TOWN OF UNDERHILL

Development Review Board

KEITH & TARA CARTER
PRELIMINARY & FINAL SUBDIVISION REVIEW
Docket #: DRB-19-09

Project Proposal:	Preliminary Subdivision Review of Keith & Tara Cater for a proposed 2-Lot Subdivision of property located at the aforementioned address. The Applicants have requested that the lot remaining as vacant lands be considered a “wood lot” in order to forgo a more in-depth review process.
--------------------------	--

SECTION 3.18 – STEEP SLOPES

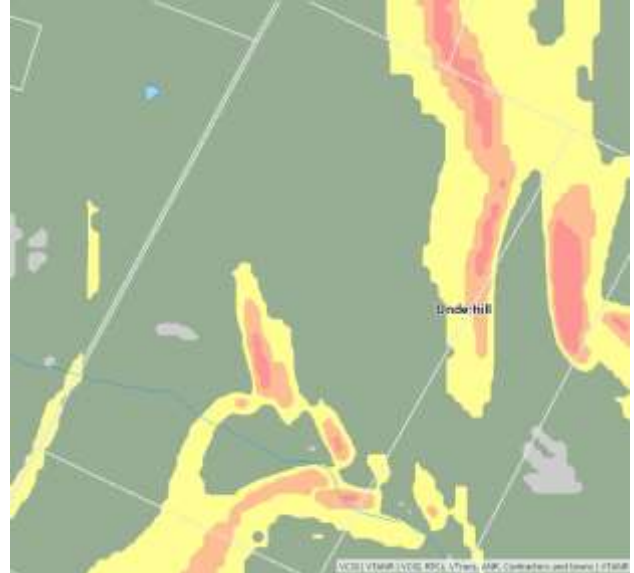
- Areas of steep slopes (15-25%) and very steep slopes exist on the existing lot (see directly to the right).
 - The existing house appears to be in an area of Steep Slopes (15-25%).
- While the second, vacant lot will remain as a “wood lot,” thereby deferring development at this time, there are areas on that lot that are outside of these steep slopes and very steep slopes, allowing for future development.
